NOTIFICATION 17-12-08

Subject: Canopy Latch/Handle Upgrade

Affected Models: All RV-12 Aircraft

Required Action: Replace old handle and latch block components with revised components.

FIGURE 1: ADDING C-01215-1

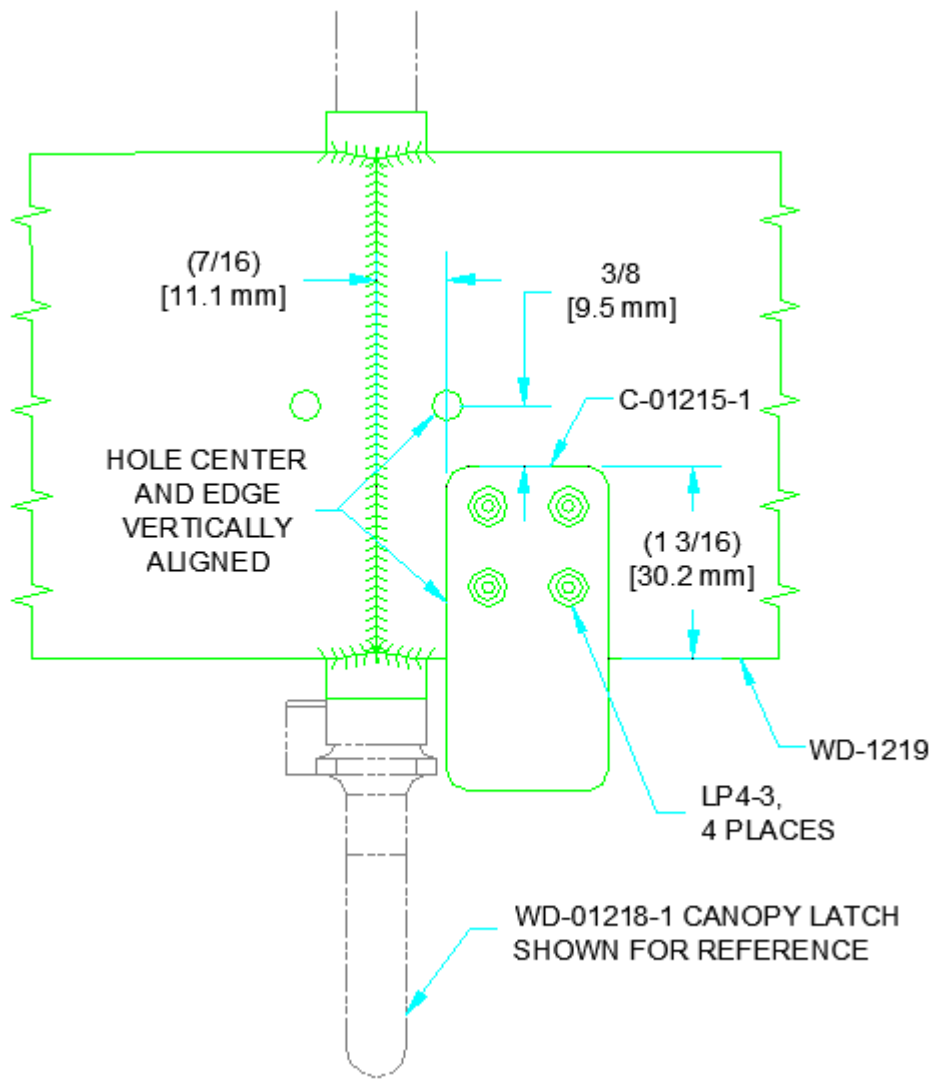
Step 2: Install the C-1215-1 Latch Handle Stop as shown in Figure 1. If installing the canopy handle for the first time use the dimensions to position and match-drill #30 the latch handle stop to the WD-1219 Canopy Frame.

FIGURE 2: PILOT DRILL CANOPY HANDLE

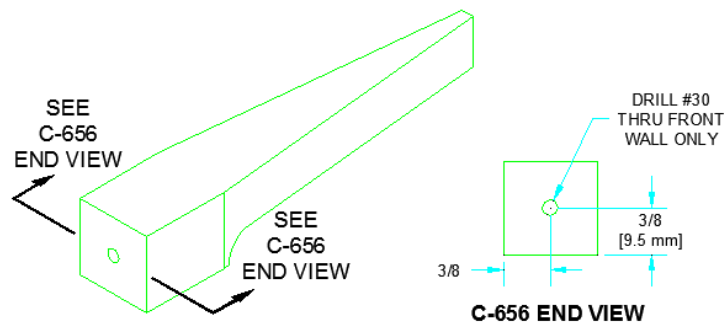
Step 3: Drill a pilot hole in the end of the C-656 Canopy Handle as shown in Figure 2. Be sure to drill perpendicular to the face of the Canopy Handle.

FIGURE 3: CANOPY HANDLE ASSEMBLY

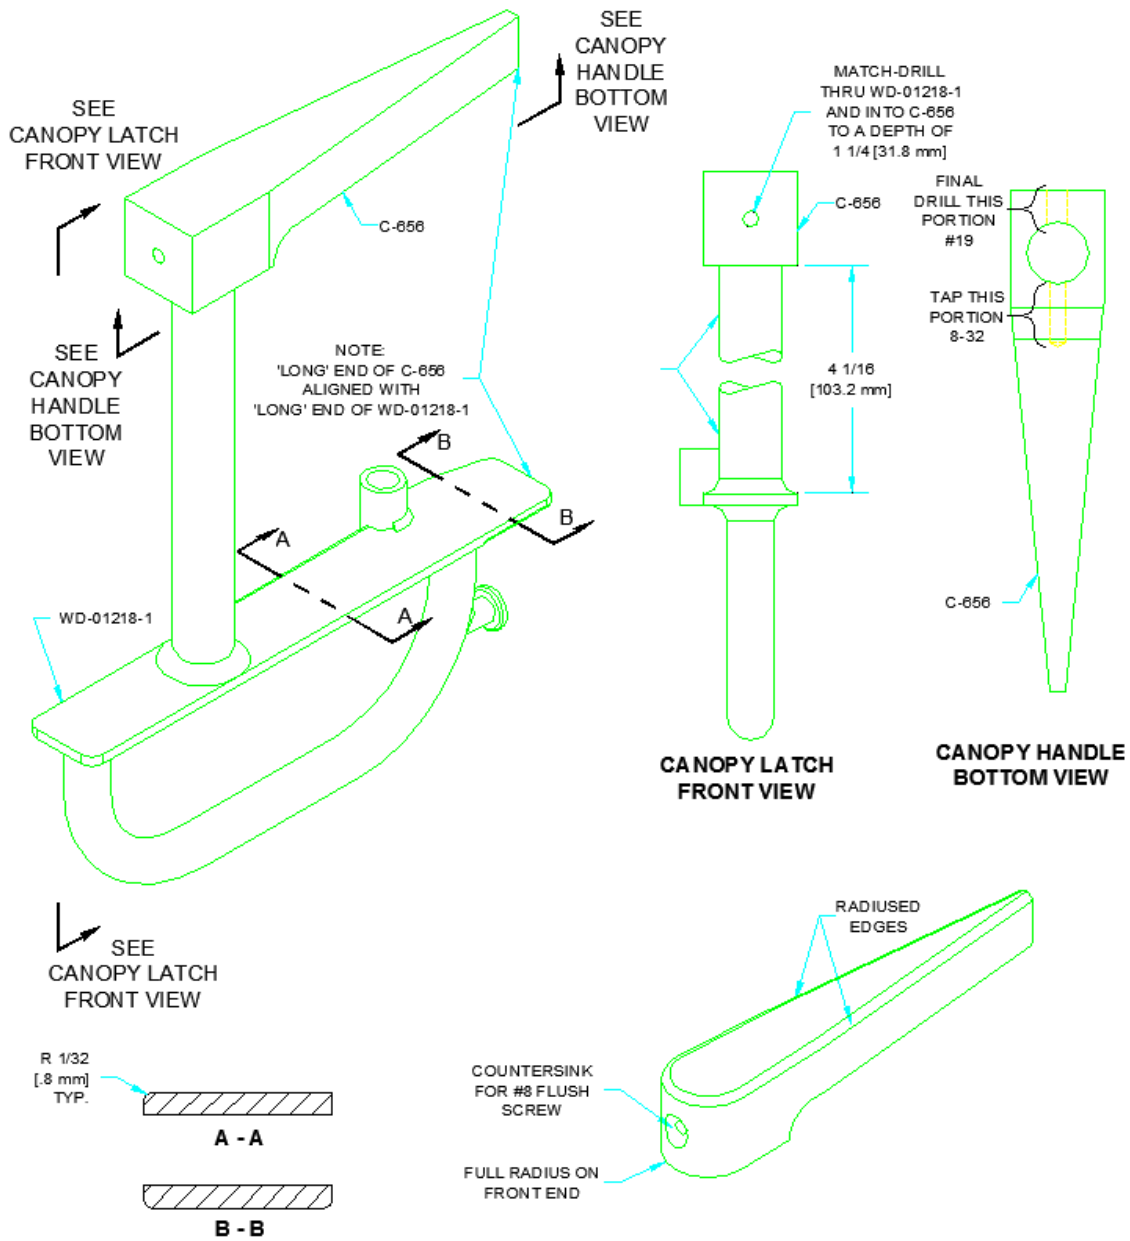
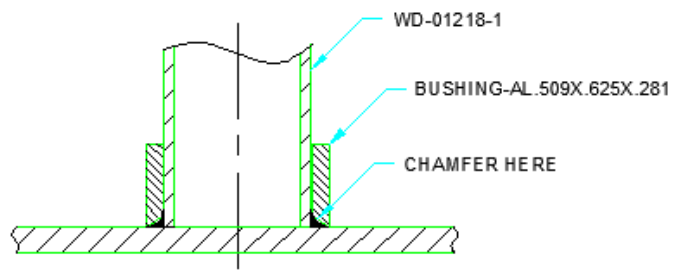
Assemble the WD-01218-1 Canopy Latch and C-656 Canopy Handle as shown in Figure 3. The tube end of the canopy latch may be shortened if/as required to achieve the dimension called out in Figure 3.

Using the pilot hole in the canopy handle as a drill guide, match-drill #30 through both sides of the canopy latch tube and into the canopy handle to the depth called out in Figure 3.

Round off the edges of the latch plate as shown in Figure 3 Sections A-A and B-B. The canopy handle edges and ends may be rounded if/as desired. See Figure 3 for an example of a final shape.

FIGURE 4: CANOPY LATCH INSTALLATION

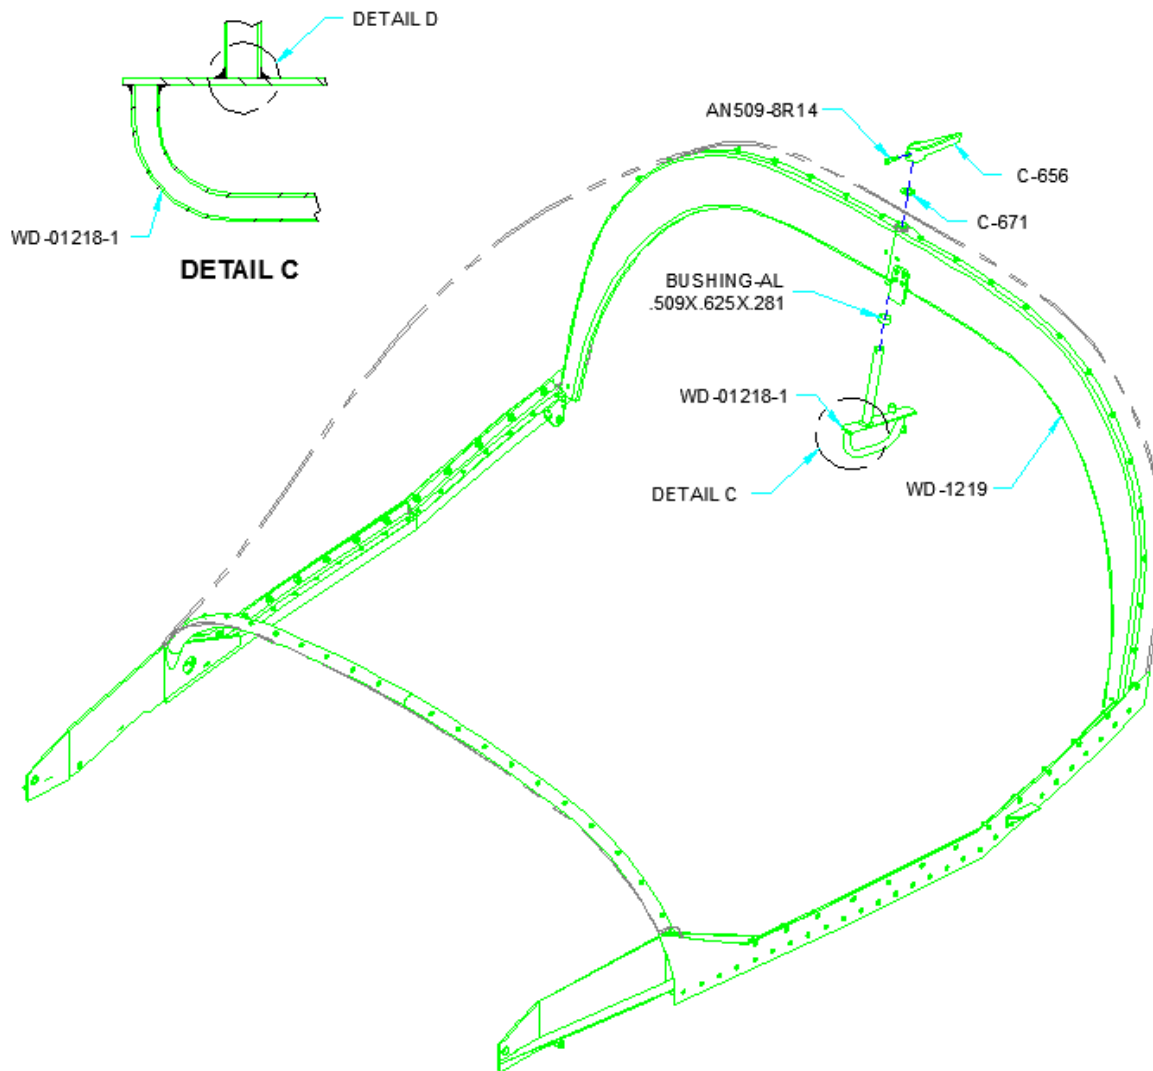
Step 4: Chamfer the inside of BUSHING-AL.509X.625X.281 allowing it to sit lower on the WD-01218-1 Canopy Latch tube as shown in Figure 4.

Step 5: Install the WD-01218-1 Canopy Latch, called out bushing, C-671 Plastic Washer and C-656 Canopy Handle on the WD-1219 Canopy Frame as shown in Figure 4.

FIGURE 5: ROLL BAR UPDATE

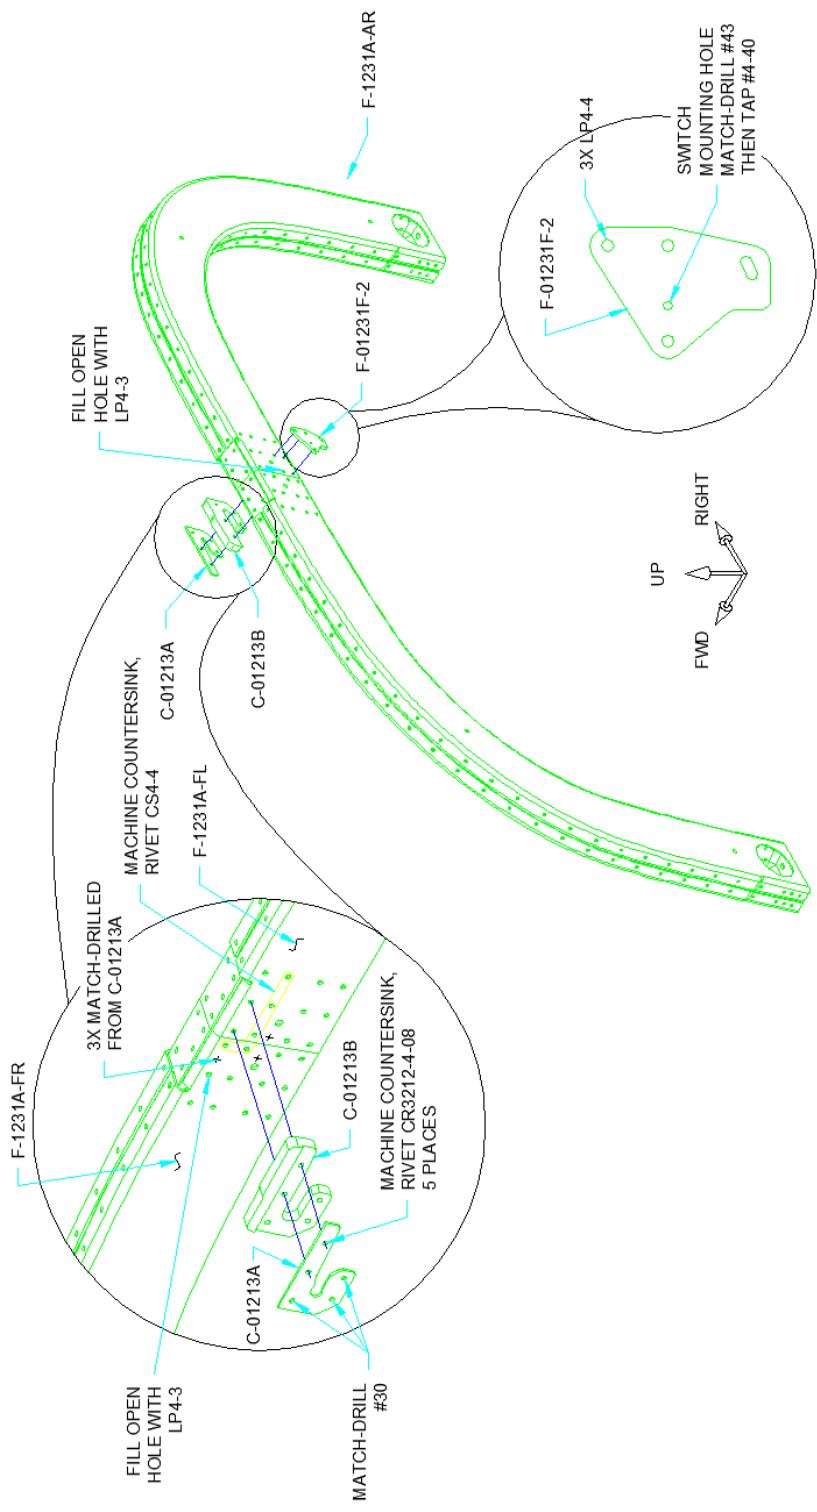
Step 6: Machine countersink C-01213A for the heads of the rivets called out in the detail view in Figure 5.

Step 7: Remove the previously installed rivets and then machine countersink the five holes on the forward face of the Roll Bar Assembly indicated in the detailed view of Figure 5.

Step 8: Cleco the F-01231F-2 to the Roll Bar Assembly. Match-Drill #43 the switch mounting hole of the F-01231F-2 into the Roll Bar Assembly. See the detail view in Figure 5.

Step 10: Rivet C-01213A and C-01213B to the Roll Bar Assembly. See Figure 5.

Step 11: Fill the open holes on the front and back sides of the roll bar frame as called out in Figure 5.

FIGURE 6: DRILLING FOR THE CANOPY LATCH BLOCK

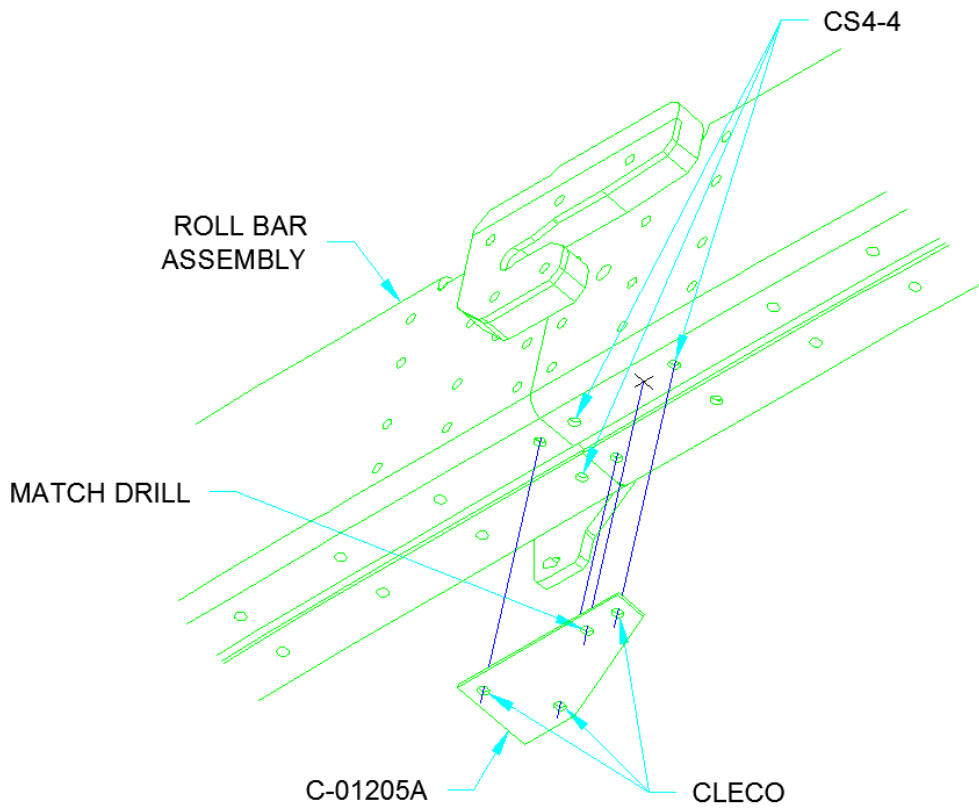
Step 12: Study Figure 6. For retrofit installations the two flush rivets near the roll bar centerline will already be installed (see Steps 13 and 14) for initial installations they will not (See Steps 15 and 16).

Step 13 (Retrofit only): In Figure 6 there are callouts for three flush rivets. The two near the centerline are already installed. The third outboard rivet is currently a domed head rivet. Remove this rivet, machine countersink the hole and install a flush rivet per the callout in Figure 6.

Step 15 (Initial Installation only): Cleco the C-01205A Canopy Block Drill Template onto the bottom of the Roll Bar Assembly as shown in Figure 6. Match-Drill #30 the indicated hole of the C-01205A into the Roll Bar Assembly. Be sure to drill perpendicular to the surface. Remove the C-01205A and deburr the hole.

Machine countersink and then rivet the three holes in the Roll Bar Assembly for the flush head rivets called-out in Figure 6.

FIGURE 7: C-01205B-2 INSTALL

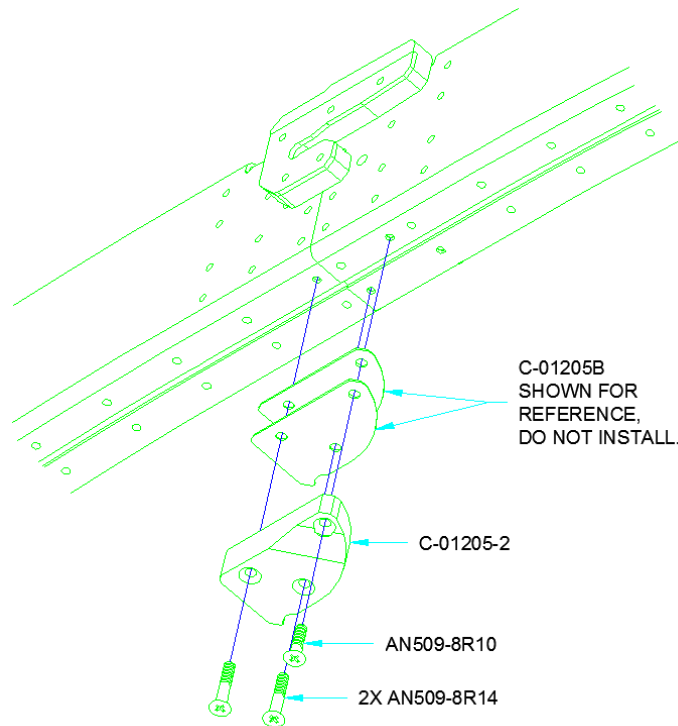
Step 14 (Retrofit only): Temporarily install C-01205-2 as shown in Figure 7 using the two fasteners near the aircraft centerline. Use the third outboard hole (corresponds to the hole marked Match Drill

Step 16 (Initial Installation only): Tap #8-32 the three holes in the Roll Bar Assembly for the screws shown in Figure 7. The C-01205-2 can be used to help keep the tap square to the bottom surface of the Roll Bar assembly: Insert the tap through one of the two holes in the thicker portion of the C-01205-2, center the end of the tap on the hole in the Roll Bar Assembly, slide and hold the C-01205-2 flush against the bottom of the Roll Bar Assembly, then tap the hole. Repeat for the remaining two holes.

Step 17: Machine countersink the C-01205-2 for the heads of the screws, then install it with the hardware shown in Figure 7. Do not install the two C-01205B's. They are installed in later steps if necessary, and are shown here for reference purposes only.

FIGURE 8: SHIM INSTALLATION

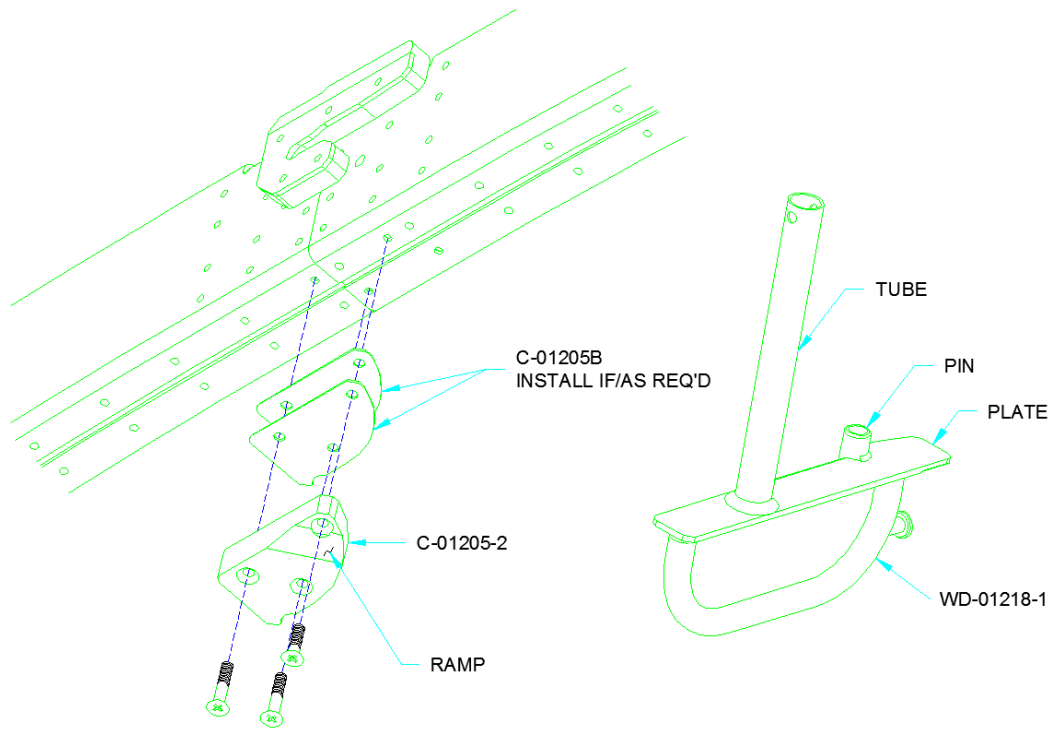
If there is any gap between the top surface of the latch plate and the lower surface of the guide block that allows canopy movement when you pull down firmly on the handle (even though the latch is fully closed and the latch pin contacts the stop) remove the guide block and add one or two C-01205B Shims between guide block and roll bar to lower the block and eliminate the gap. See Figure 8.

It is acceptable for the latch plate to strike the ramped portion of the block. See Figure 8. If the latch action is difficult adjust or trim the canopy seals to correct the latch action. If the handle needs to move downwards to improve the latching action replace the C-671 Plastic Washer and BUSHING-AL.509X.625X.281 installed in Steps 4 and 5 with the C-01223 Canopy Latch Spacer and

FIGURE 9: CANOPY LATCH SWITCH INSTALLATION

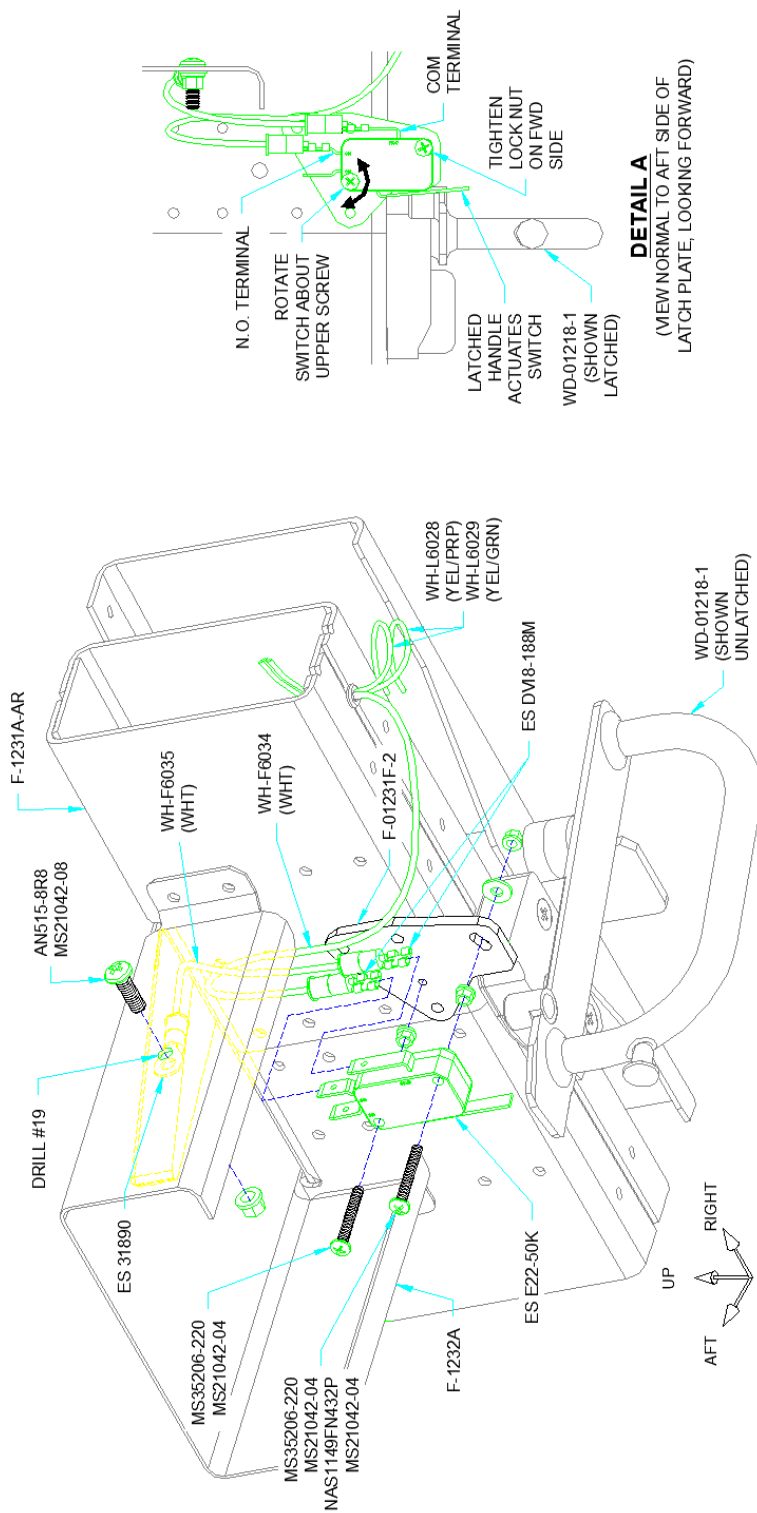
Step 23: Install the micro switch on the F-01231F-2 Latch Plate as shown in Figure 9. Insert the screws into the micro switch mounting holes and thread on the two lock nuts. Orient the lock nuts so that the flanges will contact the latch plate. **DO NOT** apply more than 3 in-lb beyond prevailing torque to the two lock nuts against the switch.

Secure the micro switch by tightening the lock nut against the washer on the forward side of the latch plate. See Detail A in Figure 9.

FIGURE 10: MODIFYING THE RETAINERS

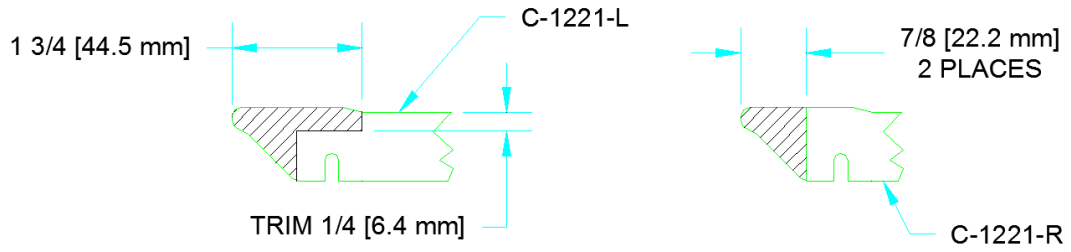
Step 18 (Seal Kit Installed): If a seal kit is installed remove and modify the C-1221-L & -R Seal Retainers as shown in Figure 10 to provide clearance between the retainers and the canopy block. Deburr and bevel the edges at the screw slots as shown in Figure 10, if desired, which aids in sliding the retainer beneath the washers.

FIGURE 11: FABRICATE THE LATCH SEAL

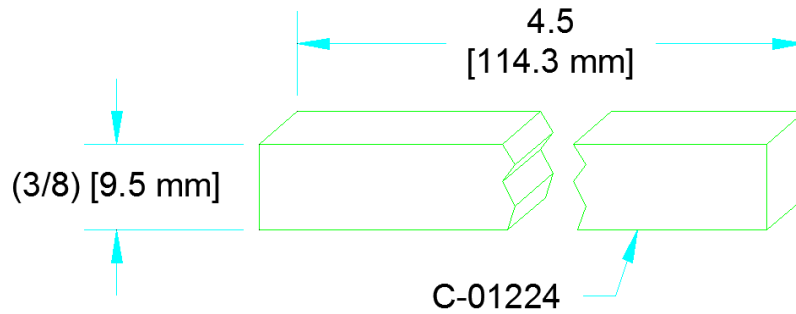
Step 20 (Seal Kit Installed): Fabricate the C-01224 Latch Seal from SEAL-00003 Foam PVC .375X.625 per Figure 11. Add relief notches for the canopy fasteners and canopy handle tube as shown in Figure 12.

FIGURE 12: CANOPY UPPER CENTER SEAL BOTTOM VIEW

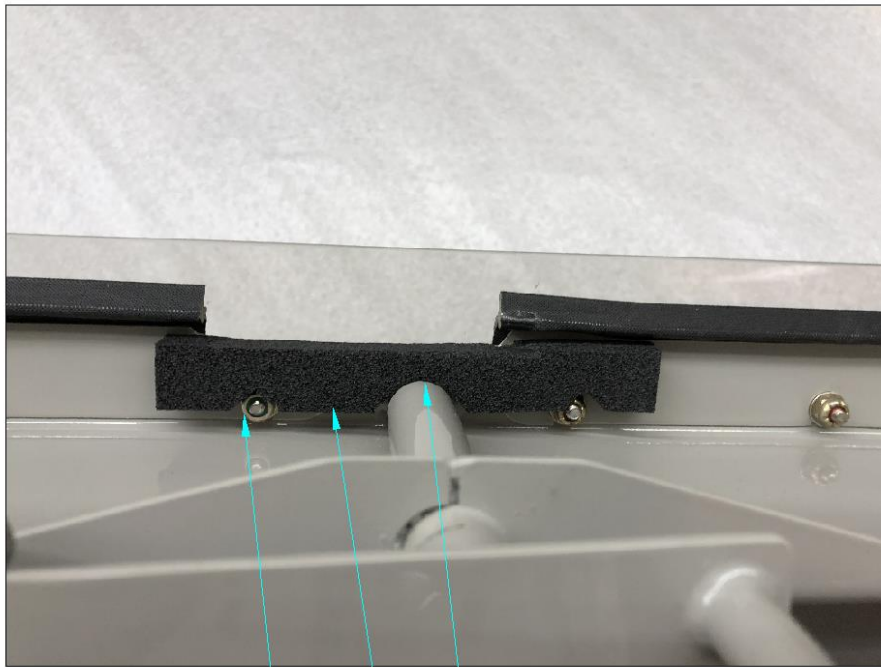
Step 19 (Seal Kit Installed): Trim the C-1220-L/R Roll Bar Seals to match the modified C-1221-L & R Seal Retainers. See Figure 12 and Figure 13.

Open the canopy and use the edge of the tape to position the C-01224 as shown in Figure 12. Remove the adhesive backing attach C-01224 to the canopy frame assembly.
